Proposed updates to Market Rule Appendices 4.2 and 4.3

Stakeholder Feedback & IESO Response from March 31st Webinar

1) **Category #1 Off – Nominal Frequency Operation**

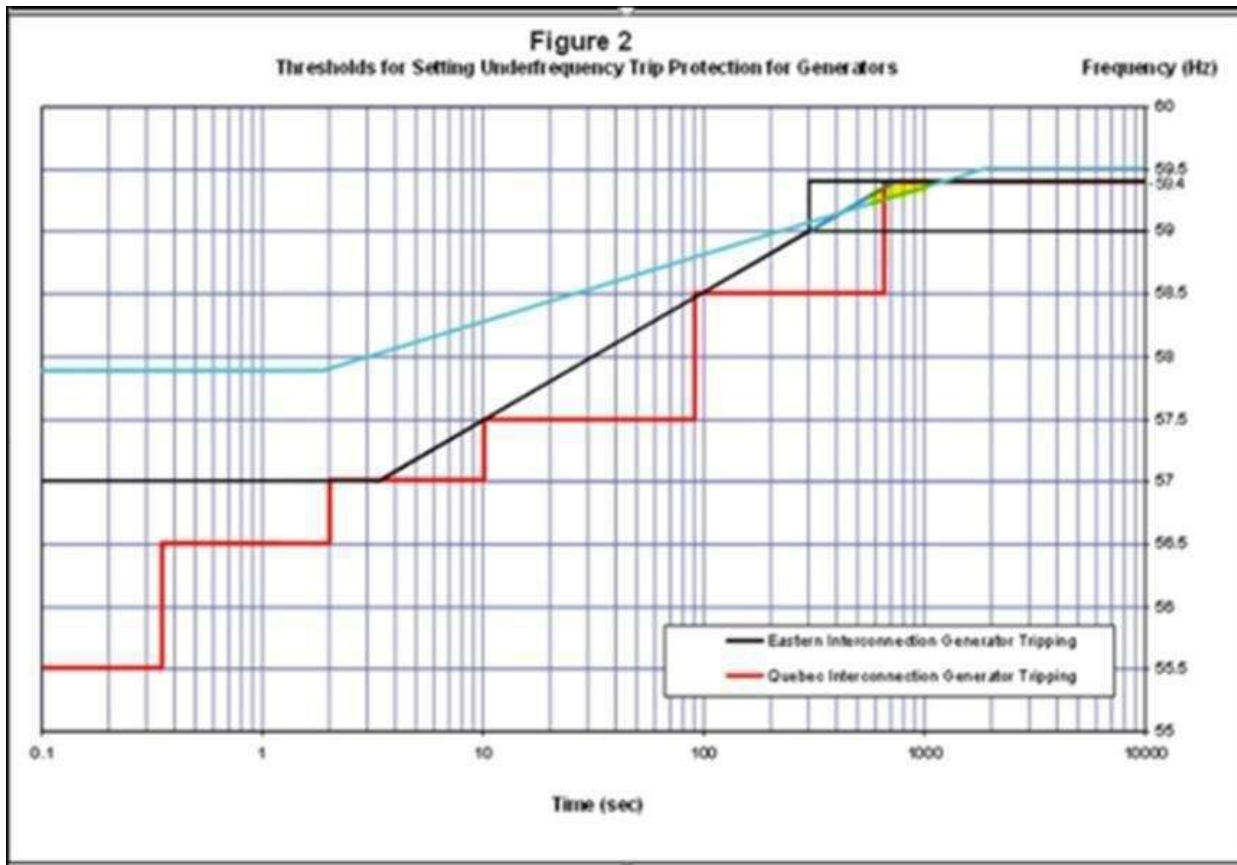
OPG is of the opinion that additional clarifications with respect to the intent of the amendment for Off-Nominal Frequency Operation are required, per the observations below.

There is a gap in the area for continuous operation and there can be cases where market participants will follow the IESO Market Rule yet will not be in compliance with the NERC Reliability Standard requirements pertaining to frequency protective relay settings.

The area highlighted in yellow on the graph below illustrates where the IESO requirements are less stringent than NERC requirements. By tripping the generating units in this area, Market Participants are compliant with the IESO Market Rules and non-compliant with the NERC requirements.

OPG would like clarification on why the IESO is introducing Market Rule requirements that are less stringent than the NERC Reliability Standard requirements pertaining to frequency protective relay settings.

For this requirement, the IESO is not proposing changes to the current requirements for under-frequency operation; the proposed change is to clarify the operation during over-frequency conditions.

The current requirements for under-frequency operation (i.e. operate continuously when the frequency is 59.4 Hz, and for a limited period of time when the frequency is above the straight line on a log-linear scale defined by the points (0.0 s, 57.0 Hz), (3.3 s, 57.0 Hz), and (300 s, 59.0 Hz)) does not prevent compliance with *NERC Standard PRC-024-2 – Generator Frequency and Voltage Protective Relay Settings* or *NPCC Directory #12* as referred to by OPG. As described in Section 3.1 in Market Manual 2.20, tripping of generation units is not permitted no matter how long operation in the region between 59 Hz and 59.4 Hz is sustained. However, generation units could be manually disconnected after consultation with the IESO operators if the frequency doesn't recover above 59.4 Hz after 300 seconds.
